TOWNHOUSES BUILDING D

CLARENDON HILL PHASE TWO POAH

ZONING SUBMISSION 06/15/2026 REV 07/22/2026

ZONING DIMENSIONAL STANDARDS TABLE

APPROVED 40B SEPTEMBER 10, 2020:
PHASING PLAN

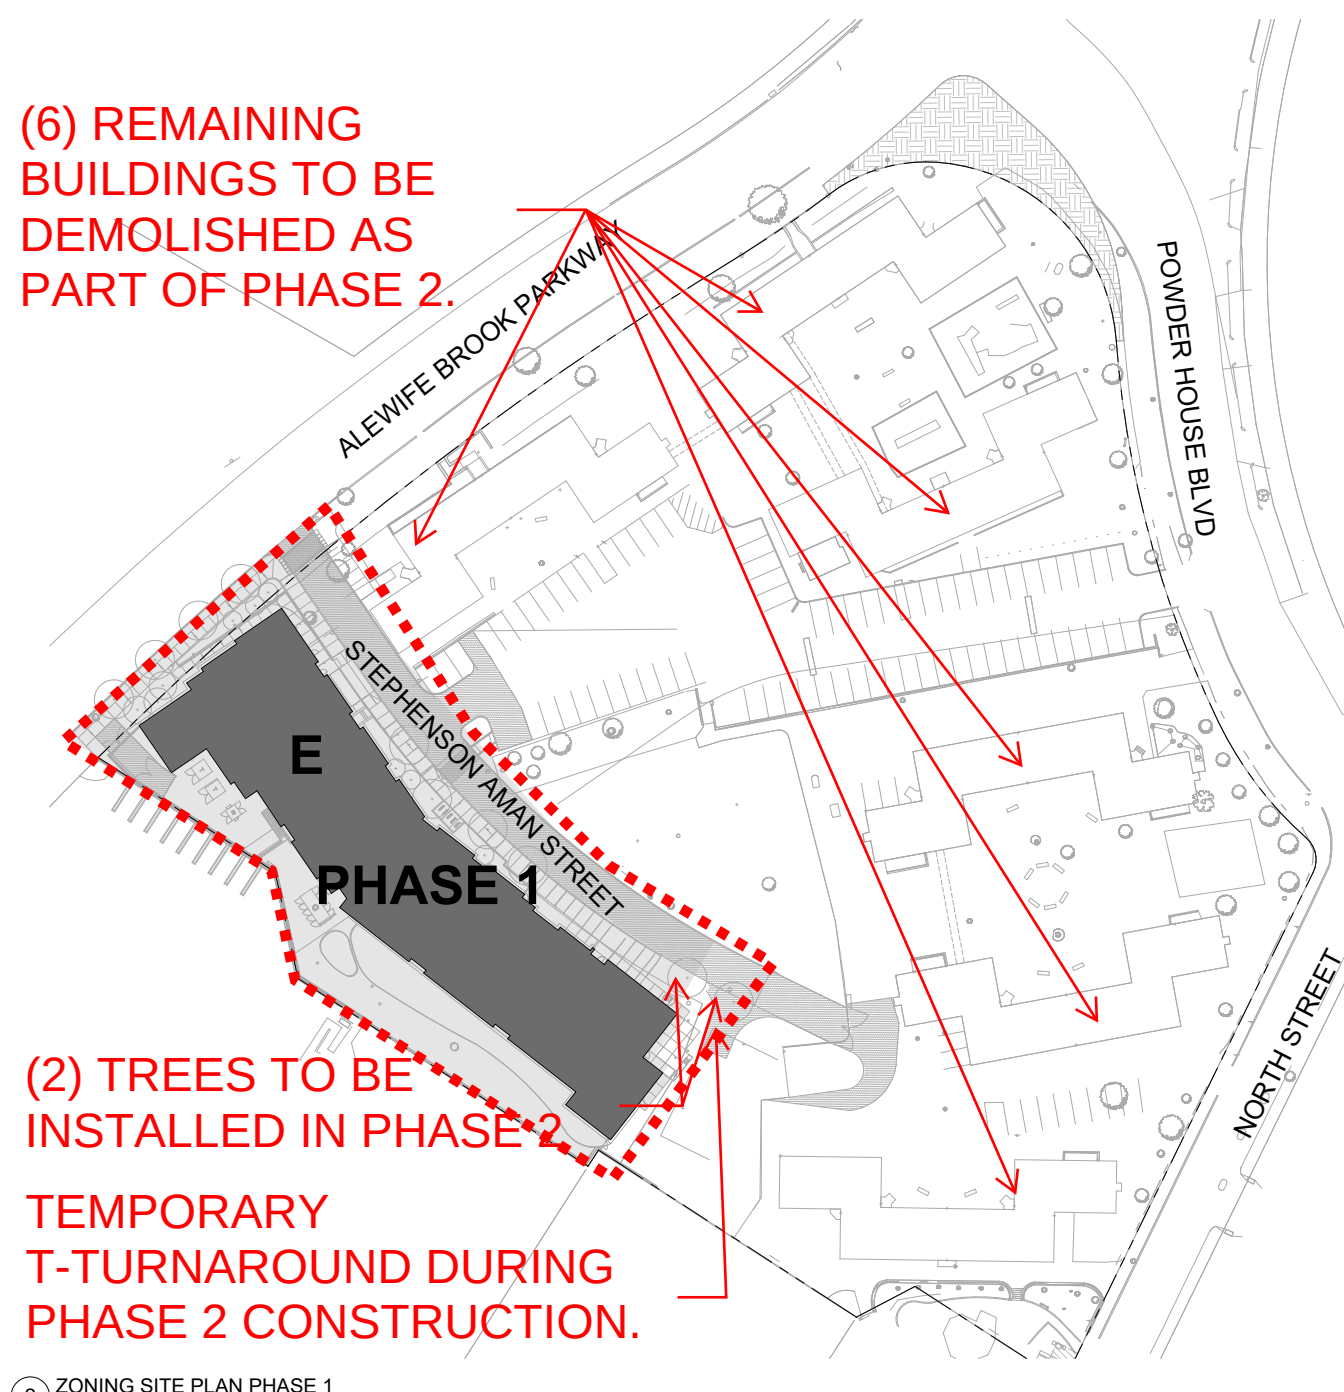
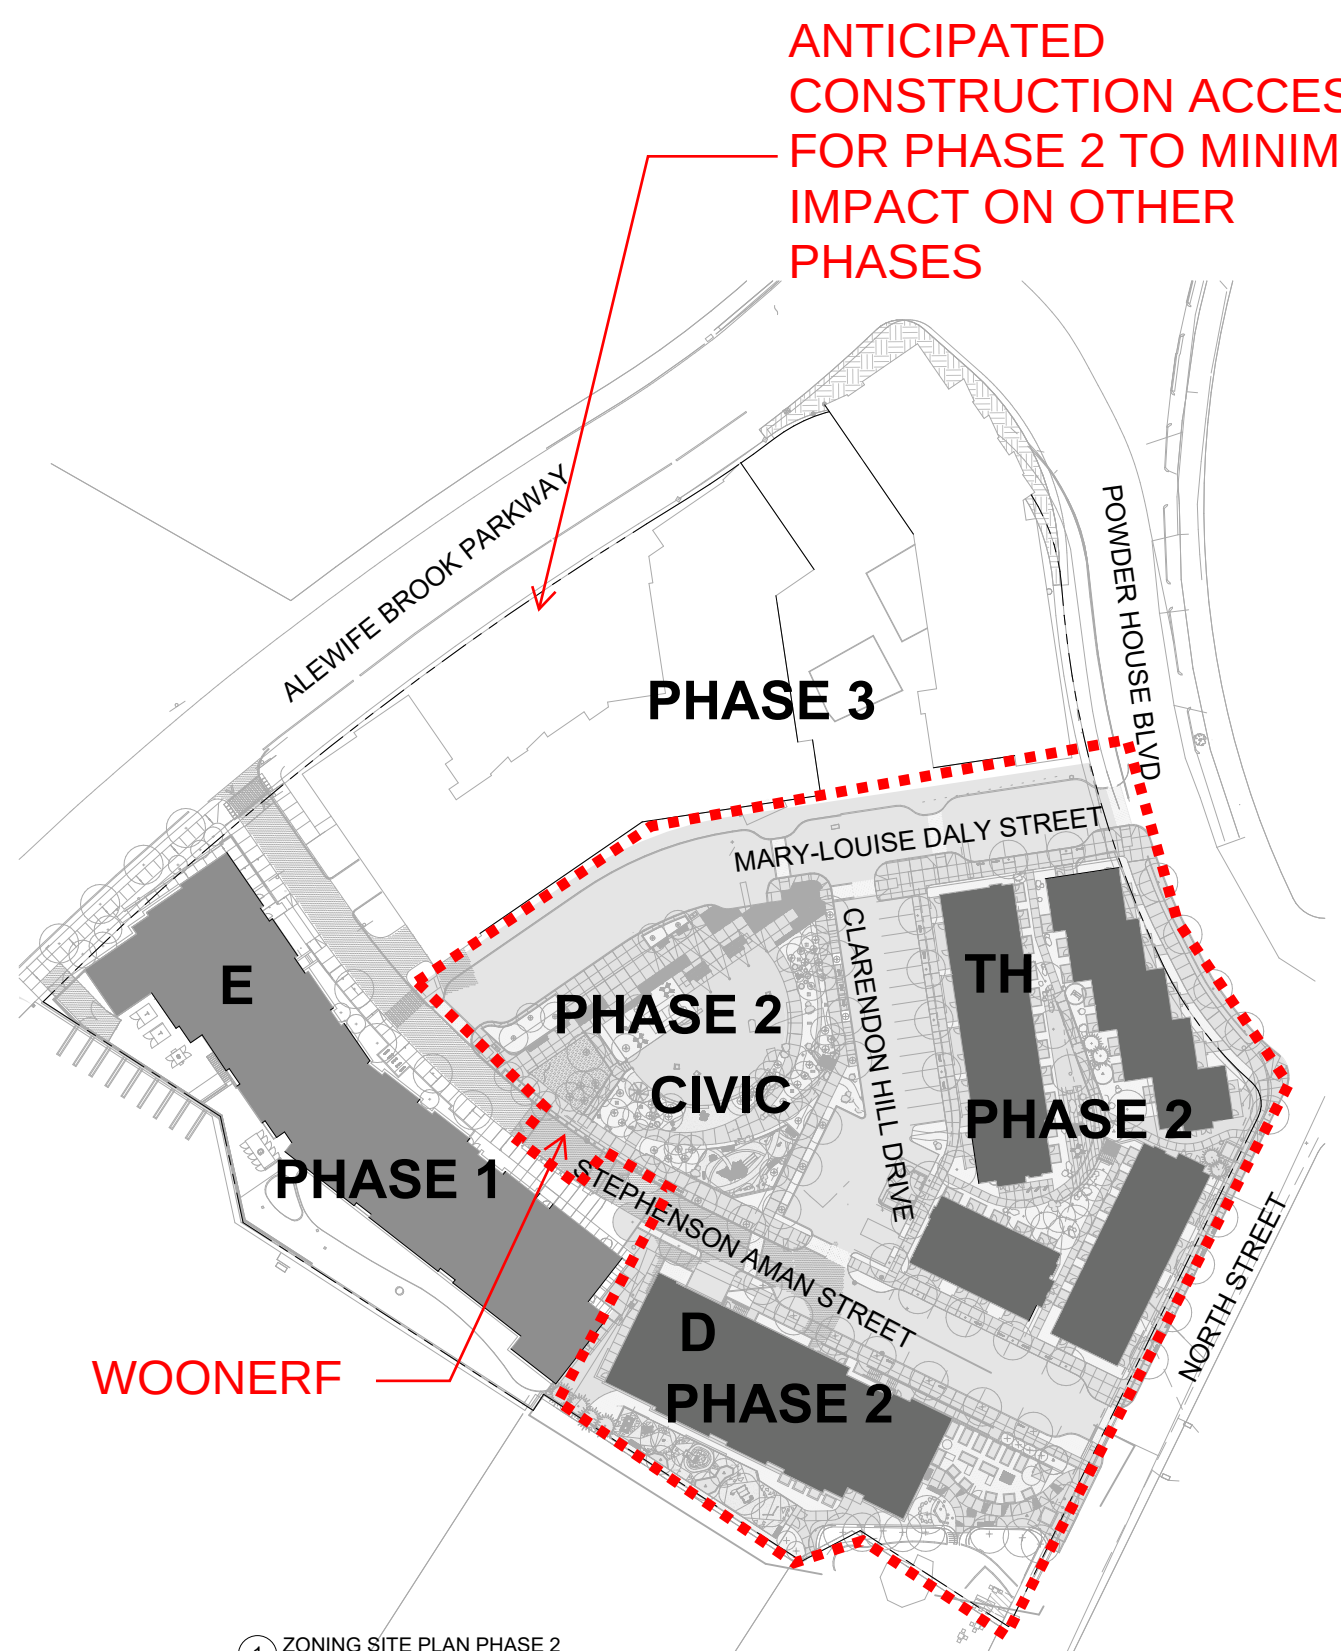
PROPOSED JUNE 15, 2026:
PHASING PLAN: PHASE 2
